Access Compliance Report

Public Rights-of-Way

(Curb Ramps)

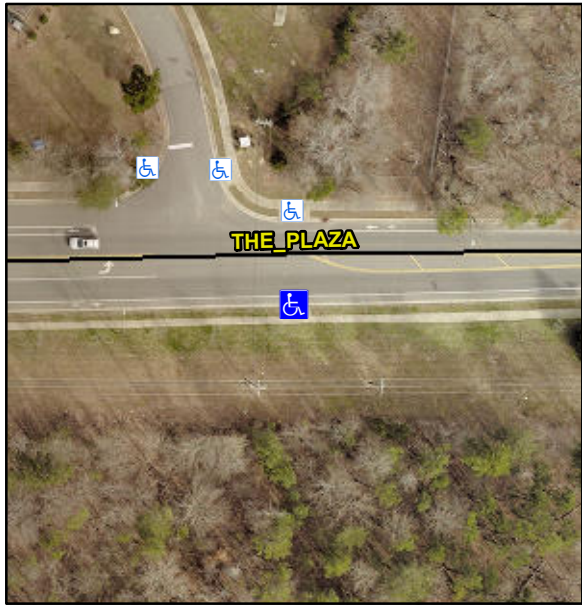
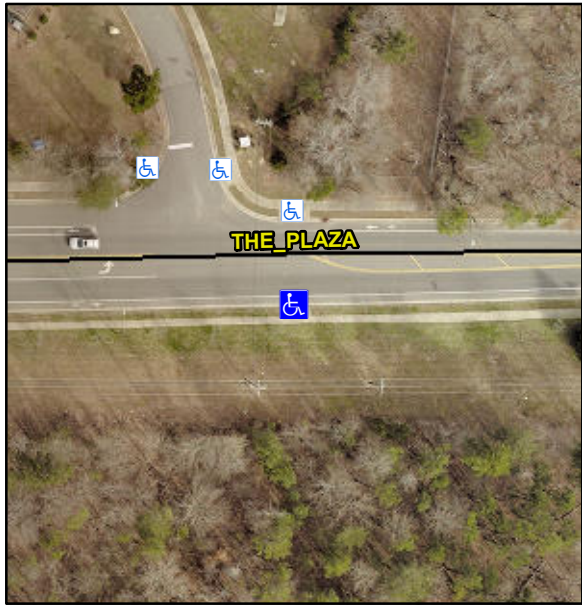
Intersection ID: 10014838		Main Street: THE_PLAZA		Cross Street: N/A		Location:		SE	
ADA ID: 71F8C68F8A48		Ramp Type: Combination2		Initial Pass/Fail: Pass		Overall Compliance: No		Severity Score: 0.25	
Codes/Mitigation Info/Possible Solution				Field Measurements/Component Compliance					
		Possible Solutions:		Compliance	Description	Data	Compliance	Description	Data
		Remove & Replace Entire Ramp.		N/A	Ramp Length LT (in)	72.0	N/A	Ramp Length RT (in)	N/A
		Remove & Replace Gutter.		Yes	Ramp Width LT (in)	60.0	N/A	Ramp Width RT (in)	N/A
				Yes	Ramp Slope LT (%)	6.6	N/A	Ramp Slope RT (%)	N/A
				No	Ramp XSlope LT (%)	2.2	N/A	Ramp XSlope RT (%)	N/A
				N/A	Ramp Length (in)	48.0	Yes	Ramp Slope (%)	5.9
				Yes	Ramp Width (in)	48.0	Yes	Ramp XSlope (%)	1.6
		Surveyor Notes:		N/A	Flare Type LT	Sloped	N/A	Flare Type RT	Sloped
		N/A		N/A	Flare Slope LT (%)	9.6	N/A	Flare Slope RT (%)	4.6
				N/A	Flare Traversable LT?	No	N/A	Flare Traversable RT?	No

PROW/ADA:		Yes	Landing Length (in)	60.0	Yes	DWS Provided?	Yes
				Yes	Landing Width (in)	48.0	Yes	DWS Contrast?	Yes
		Not Found, R304.5.3, R304.2.2-Perp, R304.3.2-Para		No	Landing Slope (%)	6.4	Yes	DWS Length (in)	24.0
				No	Landing X Slope (%)	2.7	Yes	DWS Full Width?	Yes
				N/A	Landing Curb? (Y/N)	No	Yes	DWS Offset (in)	0.0
				N/A	Shared Landing?	No			
				Yes	Gutter Ponding?	No	Yes	Gutter Slope (%)	4.9
				Yes	Gutter Lip Ht (in)	0.0	No	Gutter X Slope (%)	2.6
				N/A	Painted X Walk1?	No	N/A	Painted X Walk2?	N/A
					X Walk 1 Direction	To N		X Walk 2 Direction	N/A
Street 1 Name		None			X Walk 1 Width (in)	N/A		X Walk 2 Width (in)	N/A
Stop Condition-Street 1		THE PLAZA			X Walk 1 Slope (%)	3.5		X Walk 2 Slope (%)	N/A
Street 2 Name		N/A			X Walk 1 X Slope (%)	1.4		X Walk 2 X Slope (%)	N/A
Stop Condition-Street 2		N/A			Ramp inside XWalk1?	N/A	N/A	Ramp inside XWalk2?	N/A
					Road Slope (%)	N/A		Clear Space?	Yes

Road X Slope (%)	N/A	N/A	Clear Space to XWalk (in)	N/A
							Yes	Any Obstruction?	No
								Obstruction Type	N/A
							Yes	Storm Grate/Utility Hazard?	No
								Storm Grate/Utility Type	N/A
							Yes	Surface Condition? (G/P)	Good
								Curb Slope (%)	11.5
		Total Cost:		\$	2350.00
